STAFF RECOMMENDATION
2810 West Linden Avenue
May 16, 2018

Application: New construction – addition and outbuilding
District: Hillsboro-West End Neighborhood Conservation Zoning Overlay
Council District: 18
Map and Parcel Number: 10414009700
Applicant: Ed King
Project Lead: Paul Hoffman, paul.hoffman@nashville.gov

Description of Project: The application includes a rear screened porch addition and a new outbuilding. The outbuilding will be located ten feet (10') from the rear of the house. The outbuilding is not proposed to be a detached accessory dwelling unit as the property is zoned single-family.

Figure 1: 2810 West Linden Avenue

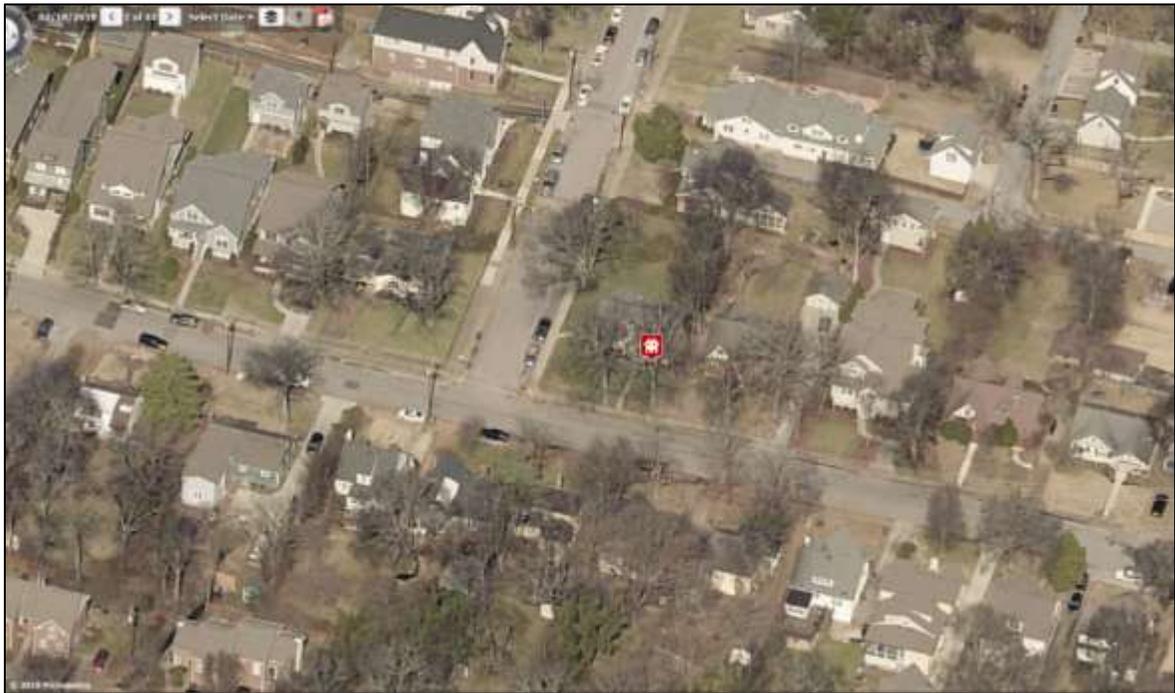
Background: 2810 West Linden Avenue was built prior to 1930 and is a contributing building in the Hillsboro-West End overlay.

Figure 2: Sanborn map from 1931 indicates an outbuilding in the same location as proposed. The lot has been subdivided since this time, so the rear property line is approximately marked by the dashed line.

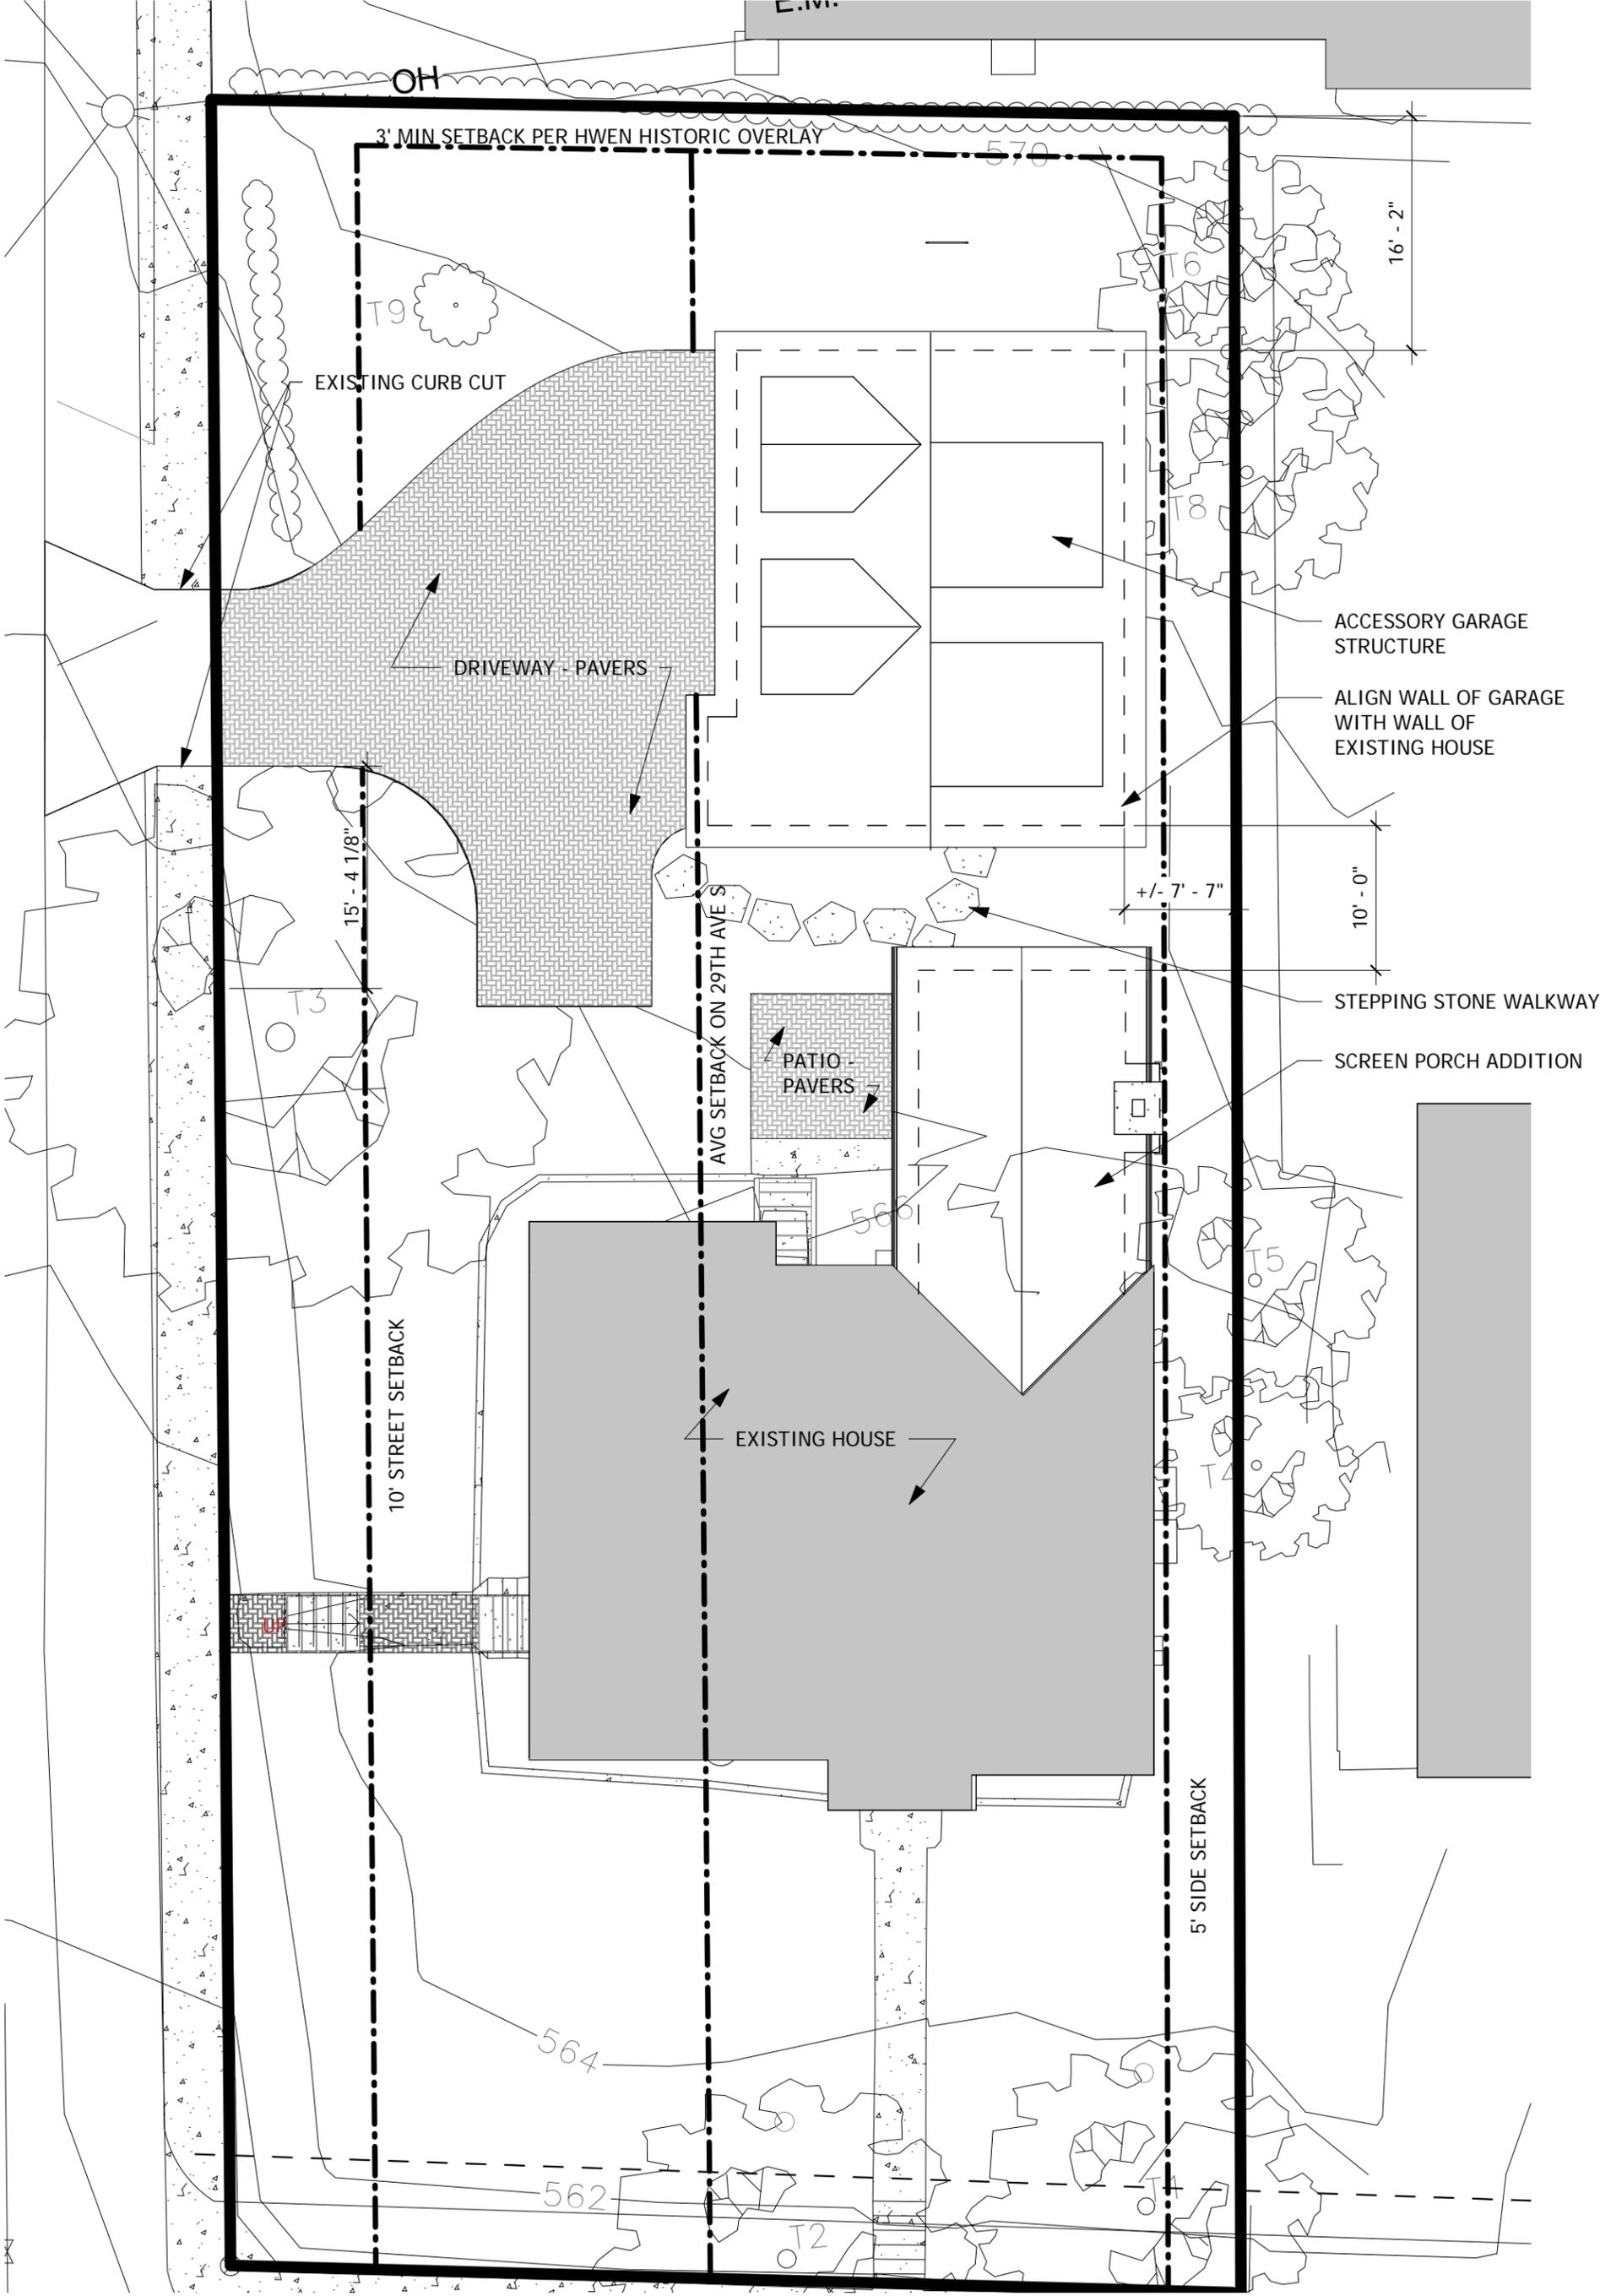
The outbuilding is proposed at only ten feet (10') from the rear of the house. The Commission has required at least twenty feet (20') of separation between the structures; however, staff finds the location to be appropriate for several reasons. The proposed new outbuilding is in the same location as an historic one (see Figure 2). There was a curb cut at this same location to access the previous outbuilding. In addition, pushing the building further towards the rear property line places the building too close to the principal building at 2218 29th Ave South (see Figure 3). 2810 West Linden was subdivided at some point, adding 2218 29th with a building oriented to the side-street so there is not the buffer of an alley between the two lots as there might be in most situations. As there has been an outbuilding in this same location historically and moving the building would place it in an inappropriate location in terms of a neighboring property, Staff finds the outbuilding's proposed location appropriate in this case.
